# SERVICE BULLETIN

**Subject: A22 Distance Encoder Sprocket Shield**

**Bulletin No.: SB10-1**

## **A22 Distance Encoder Sprocket Shield**

*Figure 1*

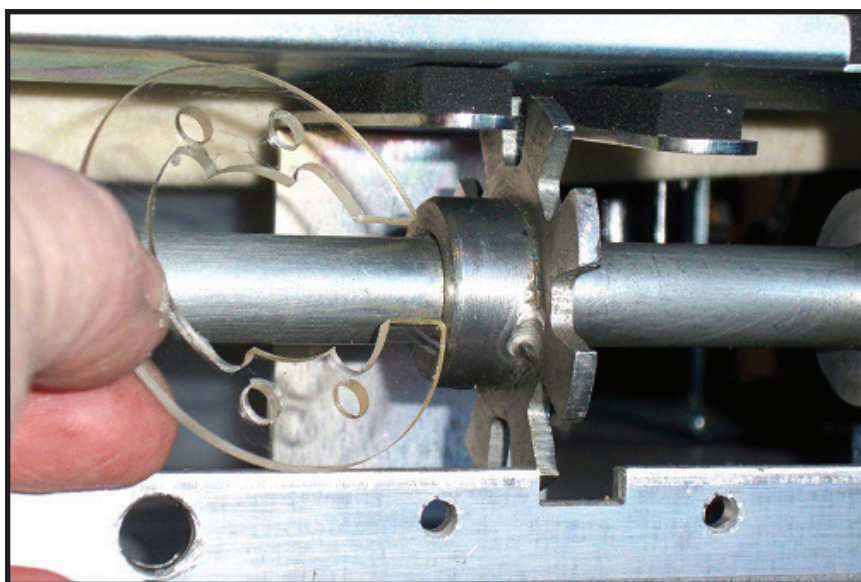
1. Disconnect the power cord from the Authority 22 lane machine and lift it into the transport position.
2. Place one of the plastic shields on either side of the distance encoder sprocket. Note that the slot in the shield allows easy installation over the shaft. Refer to *Figure 1*.

*Figure 2*

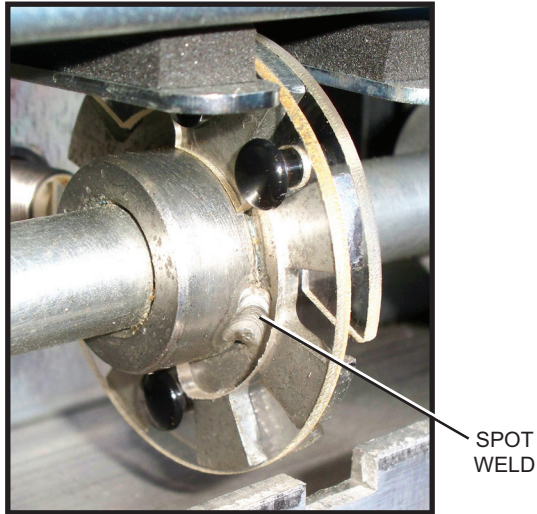
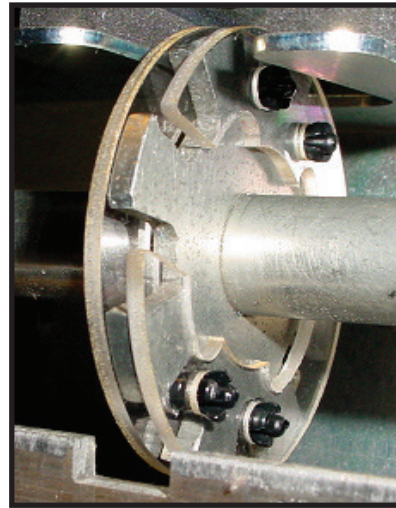
3. Refer to *Figures 2 & 3*. Position the two shields as shown, so that:
  - a. The spot weld on the hub is positioned for clearance on the shield's inside diameter.
  - b. The slots for the shaft are 180 degrees apart.
  - c. The holes are aligned so the two shields can be locked together using the plastic snap rivets provided in the kit.

*Figure 4*

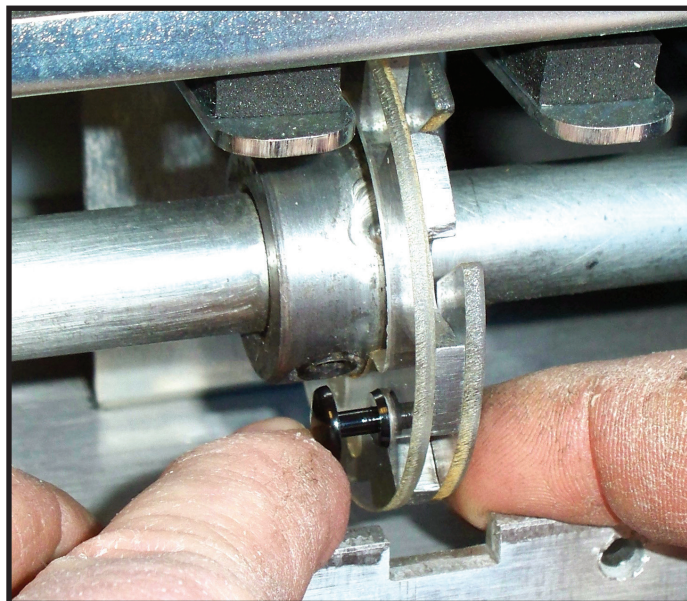
4. Hold the two shields together as the head of the plastic snap rivets are pressed to expand the end opposite the head, locking the shields together. Refer to *Figure 4*.
